<b>Company</b>	Trenz Electronic GmbH
<b>PCN Number</b>	PCN-20240705
<b>Title</b>	TE0703-07 Assembly pull-down resistor R36.
<b>Subject</b>	Assembly pull-down resistor R36.
<b>Issue Date</b>	2024-07-22

### 2.1 #1 Assembly pull-down resistor (R36).

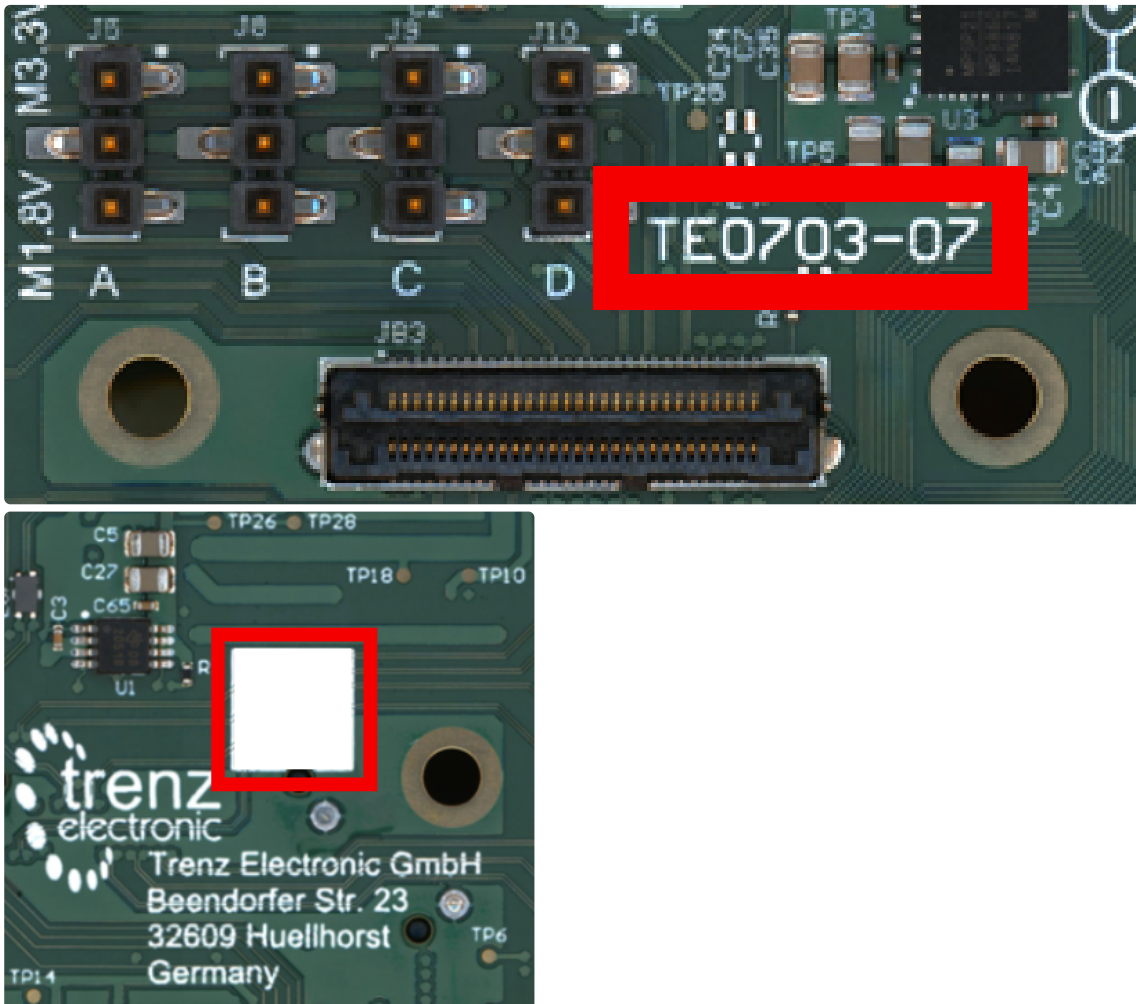
**Type:** BOM Change

**Reason:** Do not allow floating signal "OTG\_ID" for host only applications.

**Impact:** None.
